Date: March 28, 1985  
To: All Computer Service Personnel  
From: Ken Brookner *KB*  
Subject: Tandy 6000 Memory Board Precaution

# TANDY 6000 AND TANDY 6000 UPGRADE CHECKLIST

DATE: January 16, 1985  
REVISION DATE: February 13, 1985  
BULLETIN NO.: 6000:1  
PRODUCT: 26-6021/2 (Tandy 6000)  
26-6014 (8 MHz CPU upgrade kit)  
SUBASSEMBLY: 8 MHz 68000 CPU board

DATE: March 18, 1985  
REVISION DATE: March 10, 1986  
BULLETIN NO.: 6000:8  
PRODUCT: 26-6021/2 Tandy 6000  
SUBASSEMBLY: AX-9007 512k/1 meg memory board  
SUBASSEMBLY REVISION: Rev. Blank, Rev. A

**TRS-80®**SOLDER SIDE (LAYER 4)**Radio Shack®**

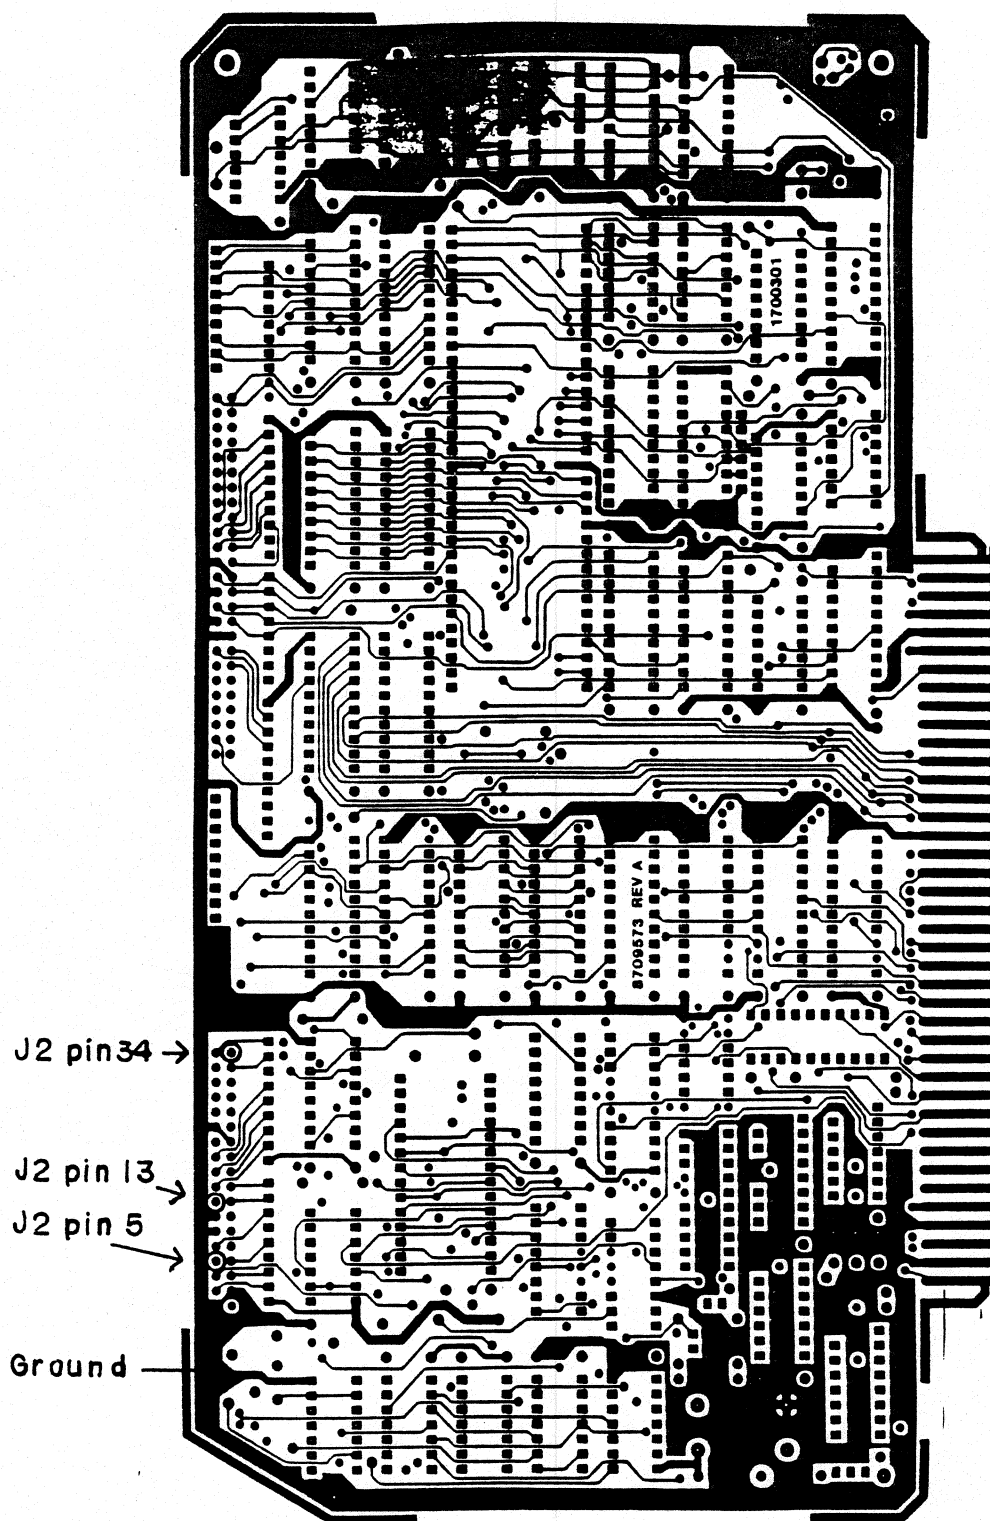
DISCUSSION:

Due to an error in the artwork on early revision (Revision A) boards, a modification to insure good ground connections between the 68000 CPU board and associated memory boards is required.

Using wire wrap wire, install the following jumpers on the solder side of the 68000 CPU board:

- (1) Jumper J2, pin 5 to ground.
- (2) Jumper J2, pin 13 to ground.
- (3) Jumper J2, pin 34 to ground.

Ground may be found at the feed-throughs on the ground plane near J2 on the solder side on the board.

Circuit Trace, Mother Board 8897701, Solder Side

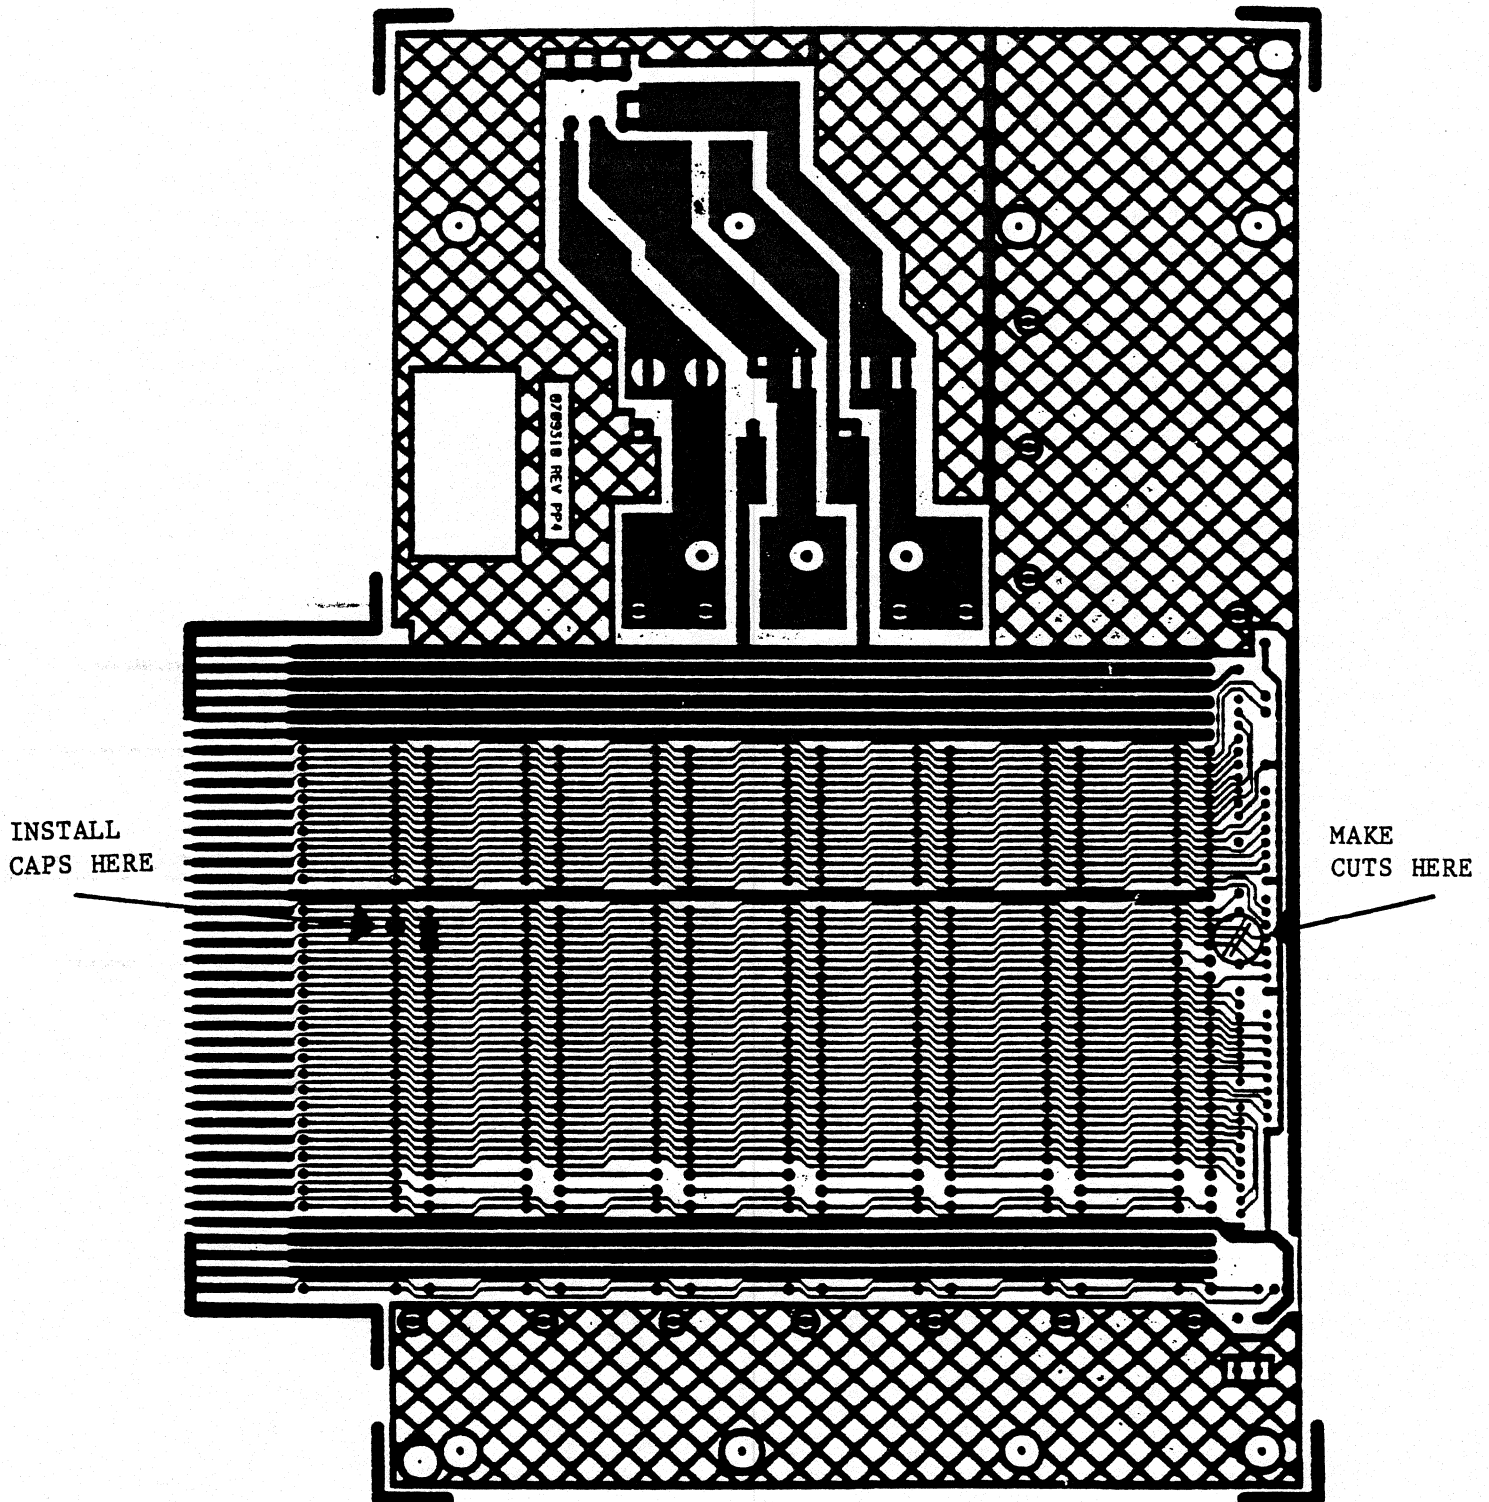
To prevent bus errors, three traces need to be cut away from a resistor pack and three capacitors need to be installed on the card cage mother board.

Due to a change in the silk-screening for the resistor packs on the card cage mother board, the actual pin to be cut on the resistor packs will be different for certain board revision levels.

On mother boards of revision levels prior to Rev. B, pins 3, 4, and 5 on resistor pack R6 need to be cut.

On mother boards of revision level Rev. B or later, pins 4, 5, and 6 on resistor pack R6 need to be cut.

On boards of all revision levels, three (3) 220 pf caps should be jumpered from pins 44, 45, and 46 to ground on the bottom-most connector. These pins correspond to the traces cut on the resistor pack R6. See Figure 1 for clarification. The capacitors needed for this modification may be ordered as:

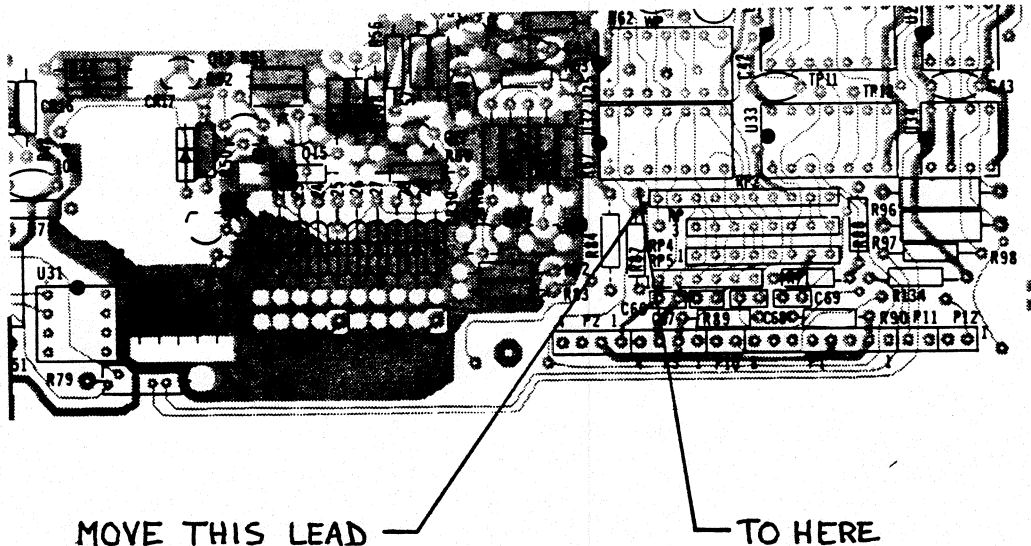
PURPOSE: To correct an error in installation of R87

**DISCUSSION:** Some Tandon Belt Drive Logic Boards (Rev. Y) have come from the vendor with R87, a 150 ohm pullup resistor, installed incorrectly. These boards may be identified by the existence of a small white sticker (bearing a bar code, three numbers, and the letter "Y") attached to the board right next to the "REV" marking. The defective boards will not see the index pulses at all and will not recognize an inserted diskette, i.e. will remain at the "Insert Diskette" prompt even after a diskette is inserted and the drive door is closed.

**PROCEDURE:** Locate R87 on the Drive Logic Board. Note that one lead is connected to a feedthrough which has a trace running to U32, pin 1. Unsolder this lead of R87 and resolder it to the feedthrough right above it. The correct feedthrough is a +5V trace.

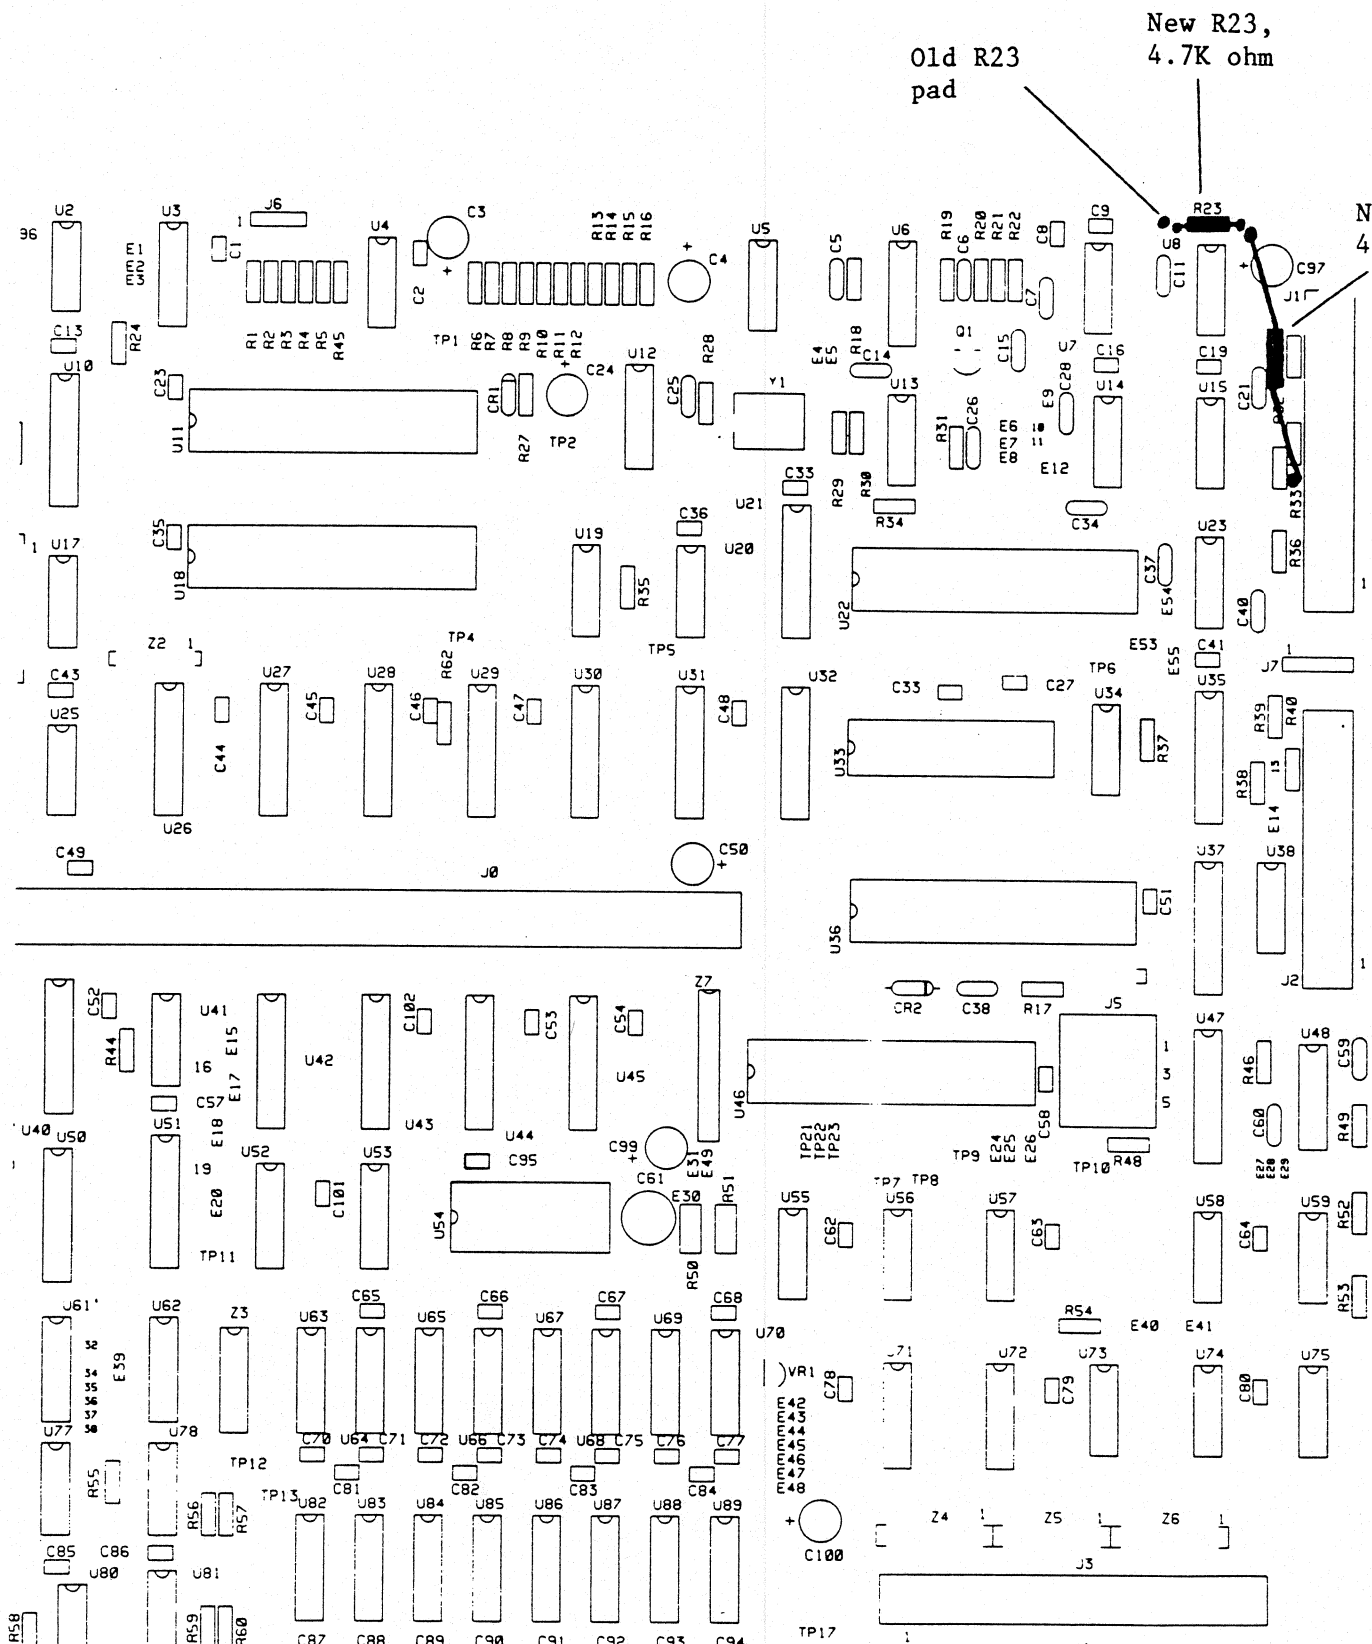
To make the serial ports more reliable the pullups for SIO control signals need to be changed. The pullup for carrier detect needs to be changed not only in value, but from -12V to +12V so that it is normally true. This modification is required on all Rev. Blank boards.

On some boards which display problems initializing port B in Xenix operation (i.e. boards which refuse to communicate with terminals on port B), an additional modification may be necessary, which pulls carrier detect normally true on port B as well as on port A. This modification may be necessary on both Rev. Blank and Rev. A main logic boards.

Change R21, R23, R25, R32, R36 from 10K ohm to 4.7K ohm resistors. Remove resistor R33. On the component side of the board, install a 4.7K ohm resistor with one lead attached to the old R33 solder connection closest to R36 and the other lead attached to the +12V line at the feedthrough adjacent to R23 between U8 and C97 (refer to figure 1). The leads should be insulated to prevent them from shorting.

Remove resistor R23. On the component side of the board, install a 4.7K ohm resistor with one lead attached to the old R23 solder connection closest to C97, and the other lead attached to the +12V line at the feedthrough adjacent to the remaining R23 solder connection. The +12V line in question also connects directly to U7, pin 14 (refer to figure 1).

All resistors required for this modification should be 4.7K ohm  $\pm 5\%$  1/4W. They can be ordered through National Parts using part number N-0247EEC with catalog number 26-9999R.
